NC STATE UNIVERSITY

Re: Technical Specifications Amendment 17
License No. R-120
Docket No. 50-297

Summary of Changes

Previous normal ventilation system data:

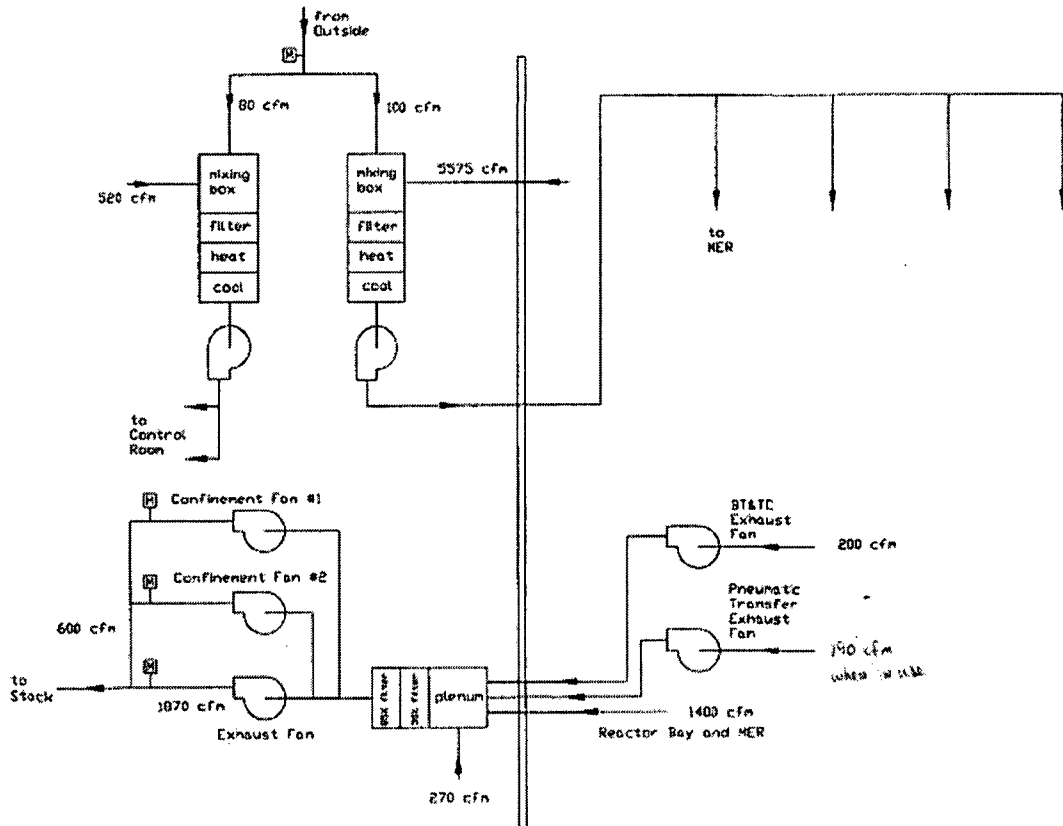
Changes made to the normal ventilation system exhaust pattern and flow rates have increased the concentration of radioactive material exhausted from the PN system by approximately a factor of 5:

Total normal exhaust = 10,050 cfm
 PN fan (intermittent use) = 190 cfm
 Total normal exhaust with PN use = 10,240 cfm

VENTILATION AND RADIATION MONITORING SYSTEM DIAGRAM

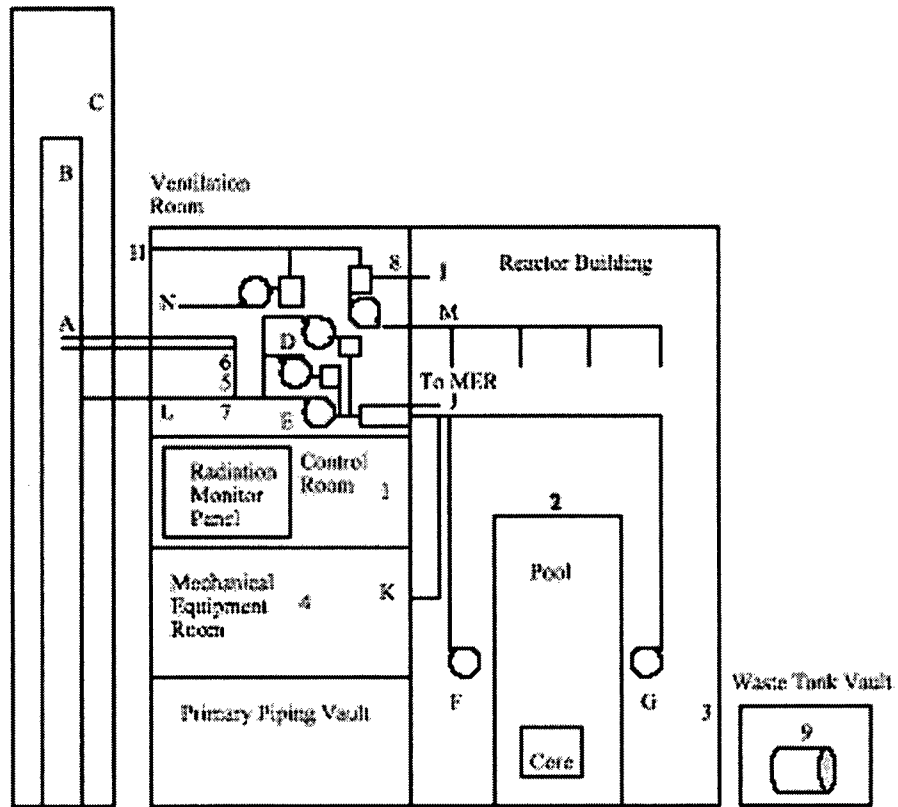
The reactor building ventilation system was modified for air conditioning by an approved design change in 2006. As a result, several changes were made including re-location of ventilation system equipment and air intake, stack sampling equipment, and air exhaust connection to the reactor stack. Other changes included a decrease in the normal ventilation exhaust rate and re-circulation of air in the normal ventilation mode of operation. The confinement ventilation mode was not changed. Ventilation equipment and the exhaust radiation monitors were moved from the Mechanical Equipment Room (at the basement level) to the third floor above the Control Room (inside the reactor building). Diagrams of the new ventilation system and radiation monitor locations are given on the following pages.

In addition, the stack sampling system, stack sample pump, and location of the effluent radiation monitors were changed. The stack sampling system equipment was re-located to a lower background area above the Control Room. The previous sample pump was adjustable to 10 cfm while the new sample pump may operate up to 4 cfm. The stack gas, auxiliary monitor, and filter monitor detector responses are based on sample concentration. The stack particulate detector response is based on the sample activity collected by a filter. Sample flow rate of 2 cfm was used in determination of the particulate radiation monitor set point.

Figure 6.1-1: NCSU PULSTAR Reactor Organizational Chart

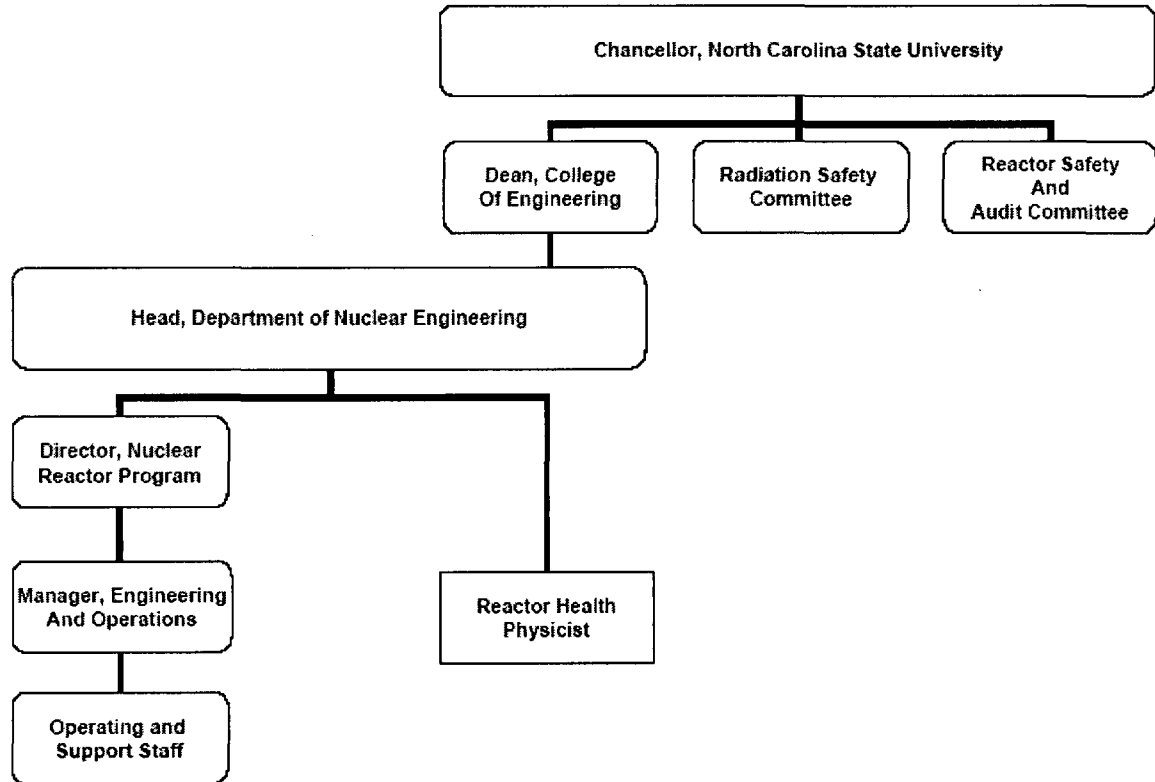
Figure 6.1-1 was changed to reflect the new organizational structure.
